# Access Compliance Report

## Public Rights-of-Way

| Intersection ID: 23318                  | Main Street: SHARON_RD_WEST | Cross Street: WINTER_OAKS_LN            | Location: NW           |
| ADA ID: 2B11A232201D                    | Ramp Type: PerpDiag         | Initial Pass/Fail: Fail                 | Overall Compliance: No |

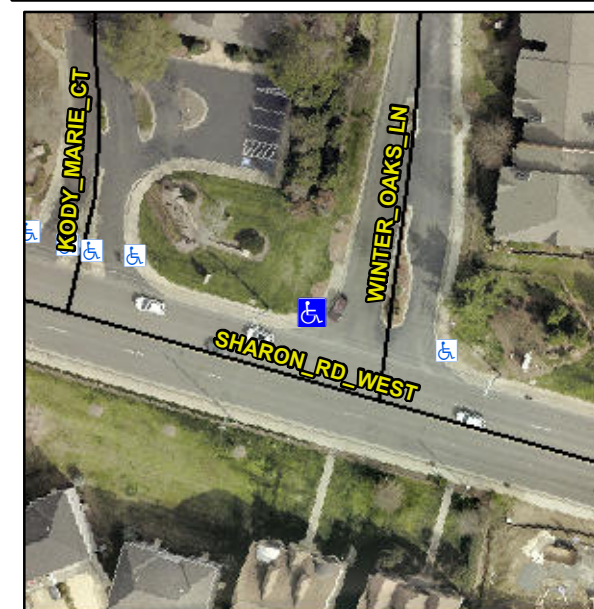
**R304.5.1, R304.2.2, R304.5.3**

| Compliance | Description           | Data | Compliance | Description                 | Data  |
|------------|-----------------------|------|------------|-----------------------------|-------|
| N/A        | Ramp Length (in)      | 59.0 | No         | Ramp Slope (%)              | 11.0  |
| No         | Ramp Width (in)       | 41.0 | No         | Ramp XSlope (%)             | 5.2   |

**Remove & Replace Curb Ramp With Two New Directional Ramps or Equivalent.**
